*Private Fuel Storage, L.L.C.*

July 20, 2001

**MAP CORRECTION: JULY 18, 2001 SUBMITTAL**  
**DOCKET NO. 72-22 / TAC NO. L22462**  
**PRIVATE FUEL STORAGE FACILITY**  
**PRIVATE FUEL STORAGE L.L.C.**

0599602

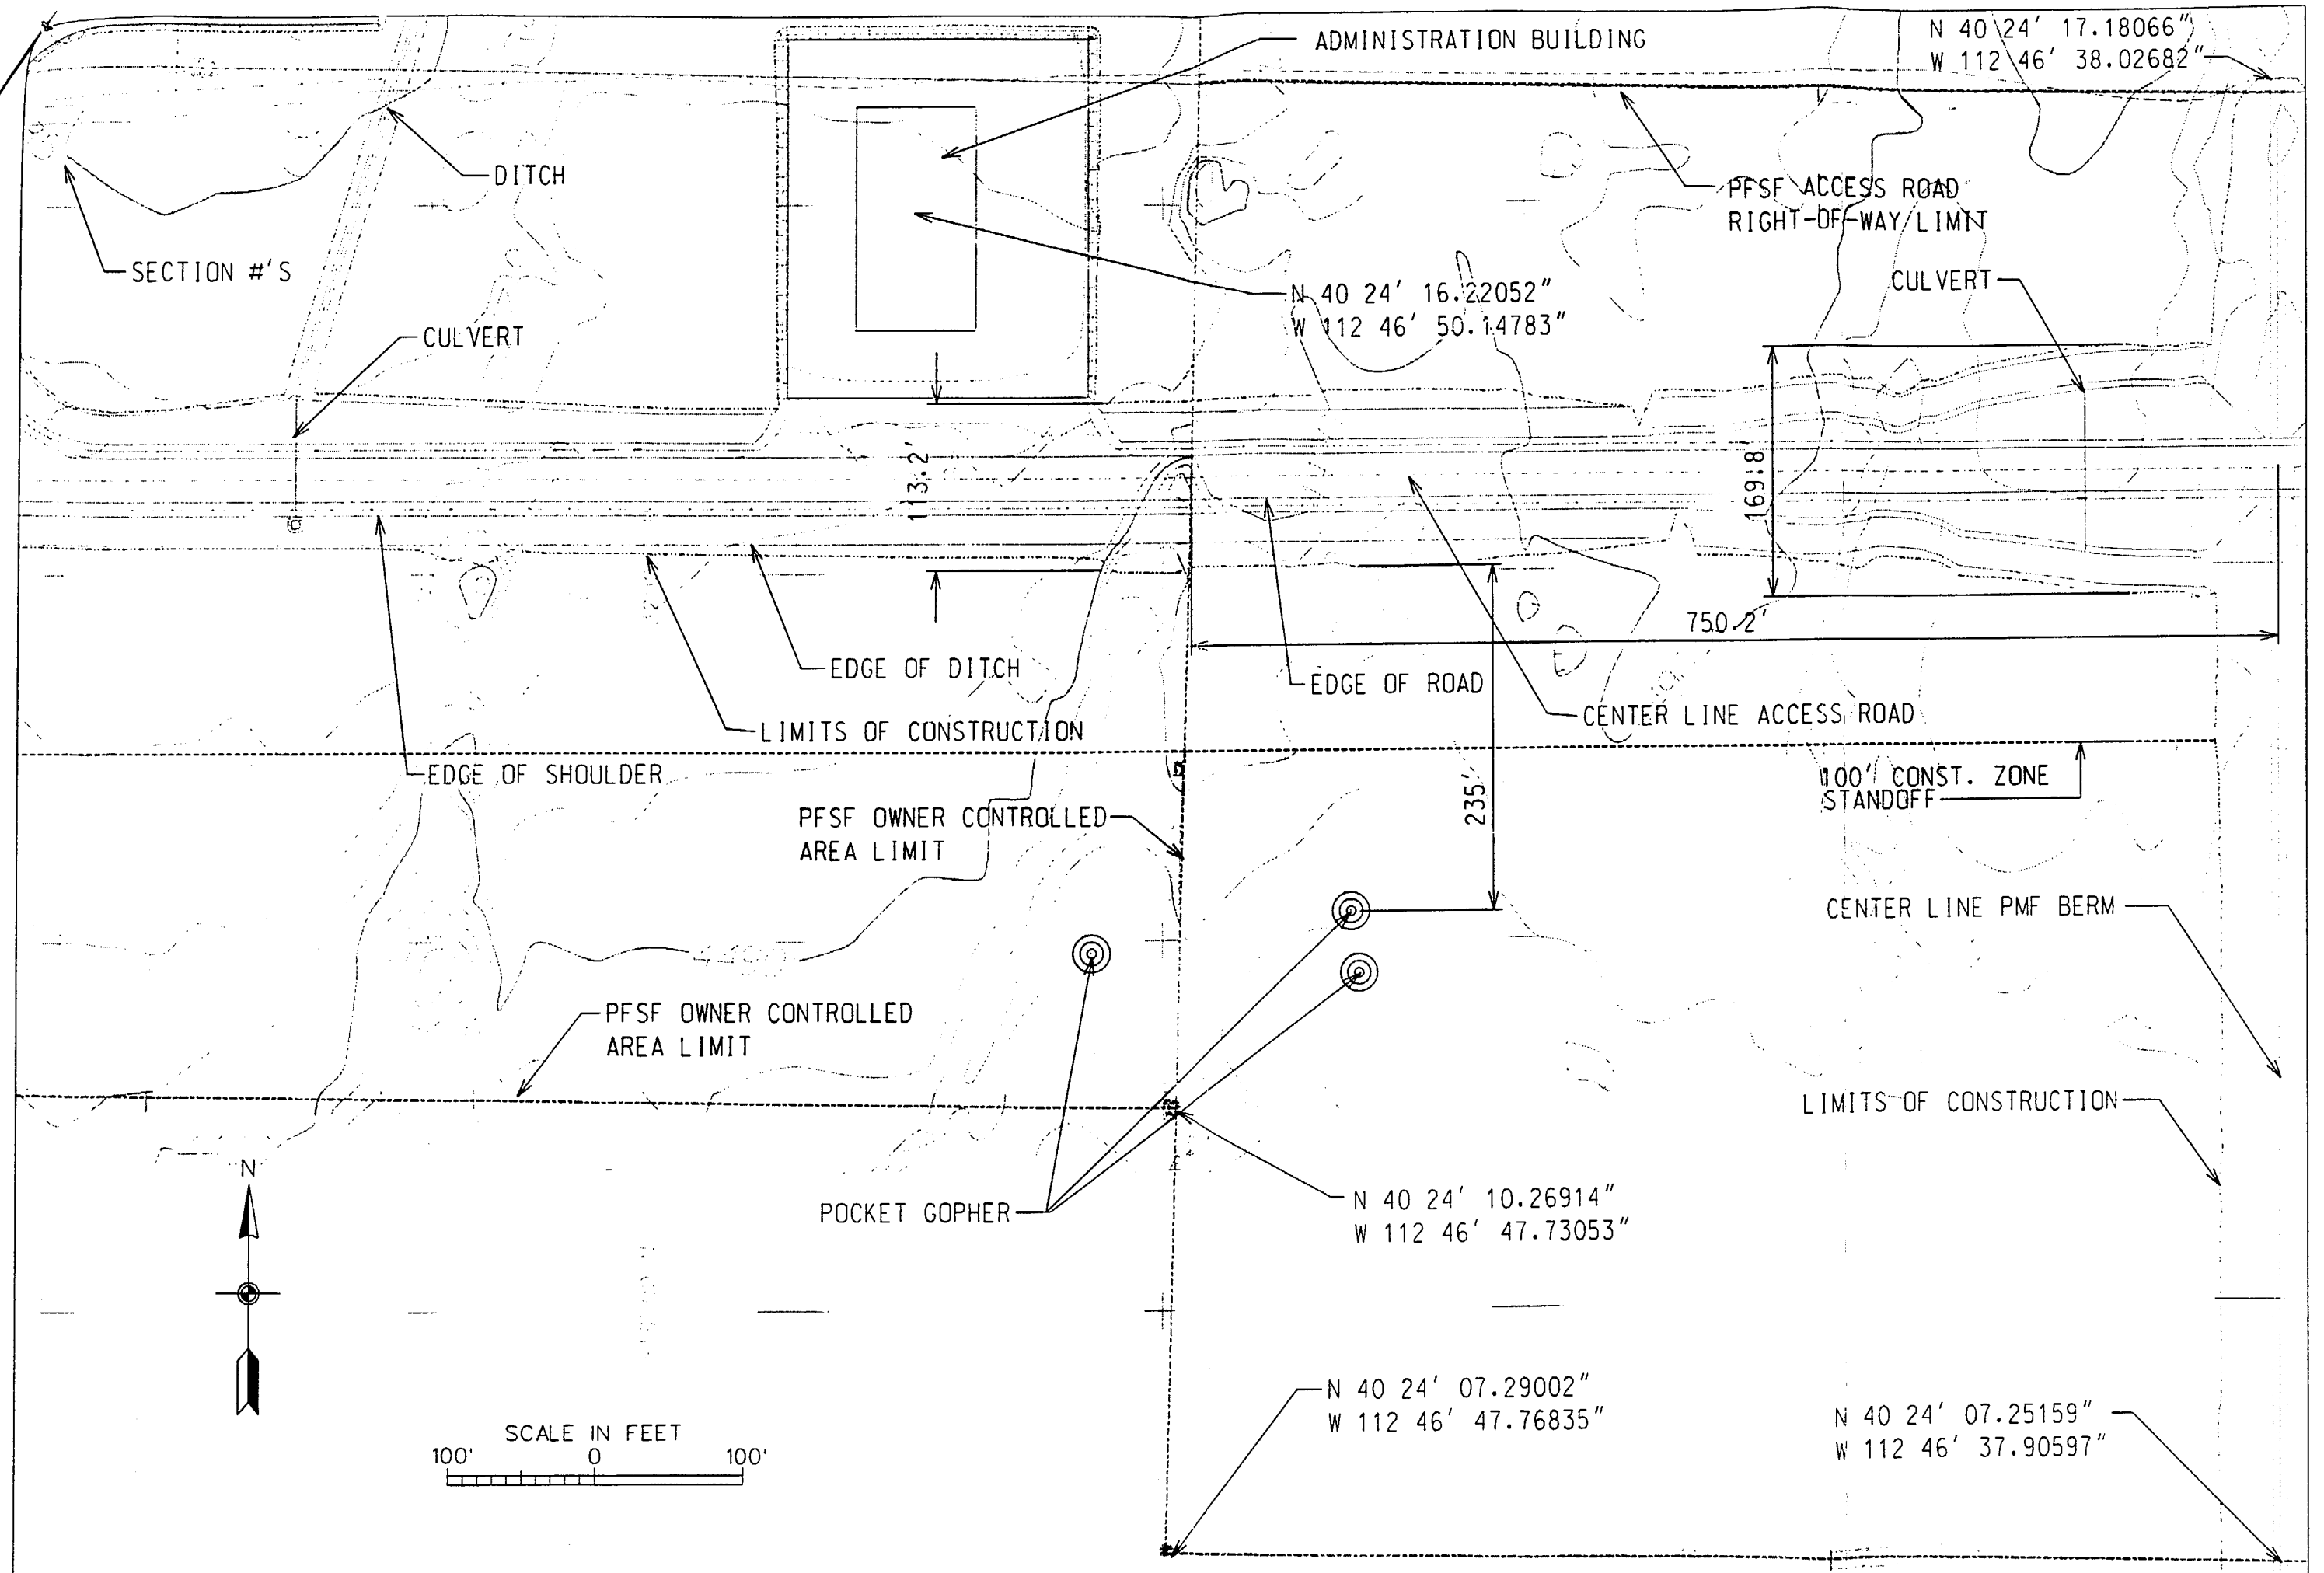
Stone & Webster provided reference material earlier this week (Reference 1) per an NRC request. It was noted that three data points in the reference material were erroneously identified by Dr. Pritchett with regard to their latitude/longitude location. Although these three points fall beyond the construction zone, PFS attempted to correct the information based on a locational description from Dr. Pritchett. However, the translation of these three points was not properly portrayed on the included map.

Attached with this letter is a corrected map showing the following three data points at their proper location. The three points remain outside of the construction zone. The PFS Environmental Report will be updated in the future to include the relevant reference material supplied to the NRC as discussed with Mr. M. Delligatti - NRC on July 19, 2001.

Pritchett - Original

N 40 24 09.1  
W 112 44 16.0

N 40 24 10.9  
W 112 44 01.9

N 40 24 11.1  
W 112 44 26.0

Corrected

N 40 24 10.5  
W 112 45 09.0

N 40 24 10.6  
W 112 45 08.4

N 40 24 10.4  
W 112 45 07.6
